HYUNDAI

Technical Service Bulletin

GROUP ENGINE MECHANICAL	NUMBER 26-EM-002H
DATE FEBRUARY 2026	MODEL(S) SANTA FE (NC)

SUBJECT: ENGINE NOISE INSPECTION & REPLACEMENT
(WARRANTY EXTENSION TXX8)

Surge Tank

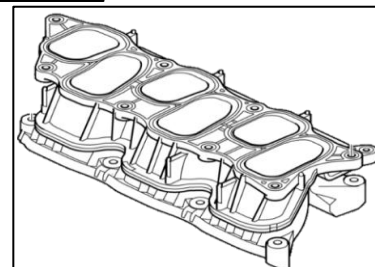
This TSB supersedes 25-EM-008H to add a surge tank and water ventilator gasket to the Parts Information section, remove the 2WD & 4WD engines (P/N: 135Q1-3CS00QQH & 137Q1-3CS00QQH) and corresponding op codes due to depleted stock, add op codes 40D245R6 & 40D245R8 for engine seized cases, and add a step differentiating the surge tank and intake manifold assembly on page 18.
